SECTION 7

EQUIPMENT

Exterior lamp

AC407315

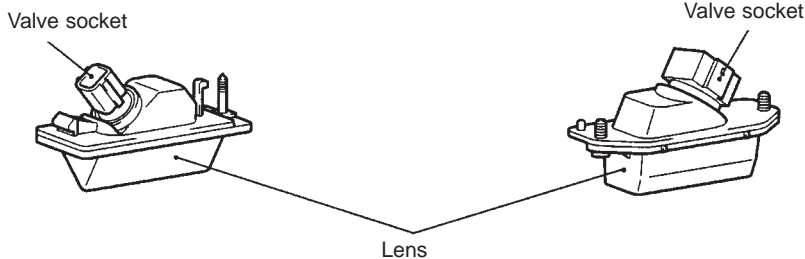
The headlamp ASSY low beam has been changed from 51W to (HB4) to 55W (H1). (Vehicles without discharge headlamps fitted).

- The shape of the number plate lamp is the same as the '03 model Lancer.

Item		New (Lancer Evolution IX)	Base model (Lancer Evolution VIII MR)
Headlamp ASSY (Vehicles without discharge headlamps fitted)	High beam W (halogen headlamps)	60 (HB3)	←
	Low beam W (Halogen headlamps)	55 (H1)	51 (HB4)
	Front turn signal lamp W	21	←
	Position lamp W	5	←
